Airworthiness Directive

Amendment 39-3071; AD 77-23-03

Airworthiness Directives; Piper Models PA-28-140, PA-28-151, PA-28-161, PA-28-180, PA-28-181, PA-28-235, PA-28R-180, PA-28R-200, PA-28R-201, PA-28R-201T, PA-32-260, PA-32-300, PA-32R-300, PA-34-200, and PA-34-200T Airplanes
PDF Copy (If Available):

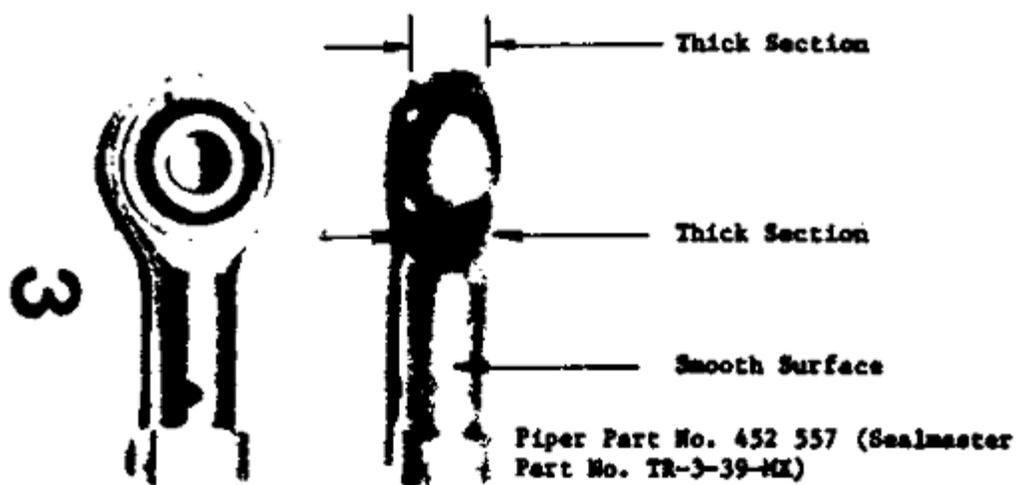
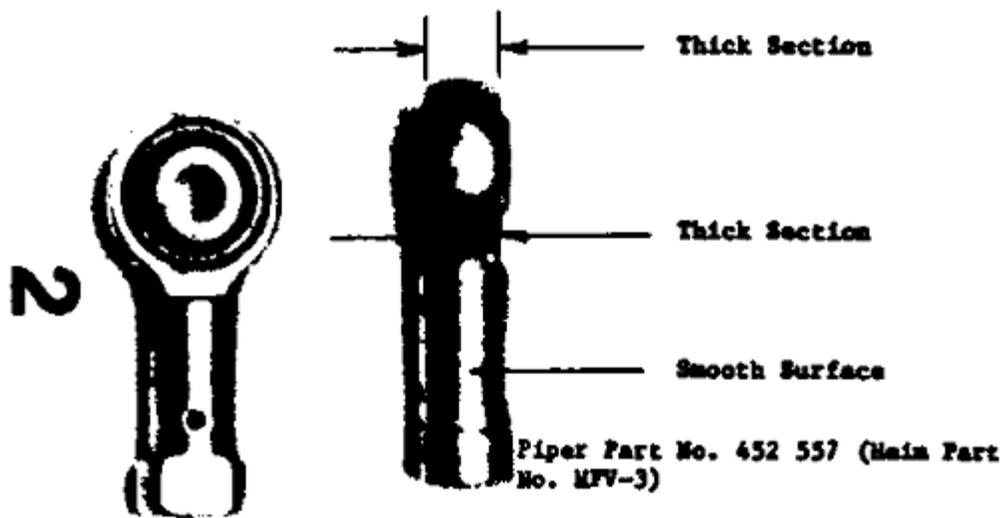
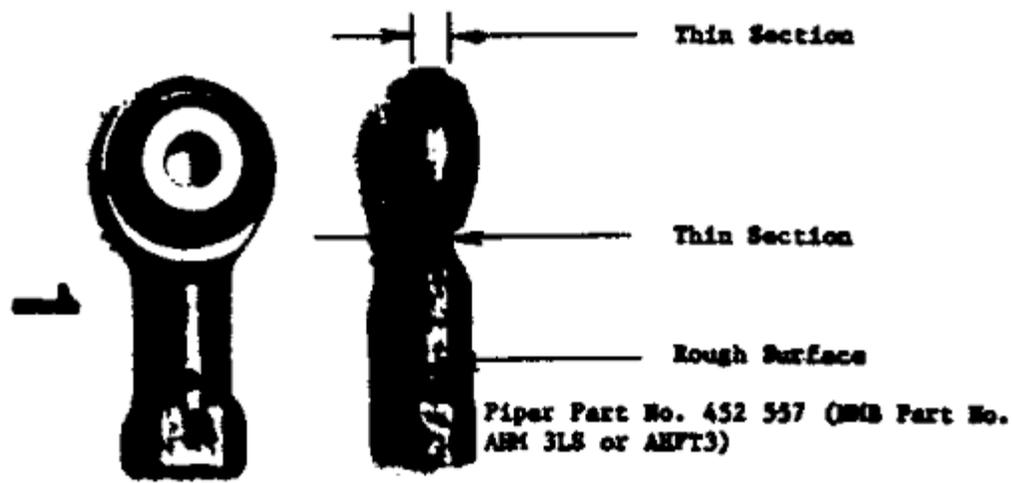
(2) Check the rod end bearings attached to the Mixture, Throttle, and Prop Governor (if applicable) Control Cables. (Refer to the picture below.)

(i) If a rod end bearing, as identified in the figure below as number two (2) (Brass Ball Retainer) or as number three (3) (Silver Ball Retainer) is installed, then no further action is required. Make appropriate log book entry.

(ii) If a rod end bearing, as identified in the figure below as number one (1) with a raised ball retainer is installed, have it removed and replaced with an approved serviceable bearing which is identified in the figure below as number two (2) or number three (3). Refer to the appropriate Piper Service Manual for replacement and rigging instructions.
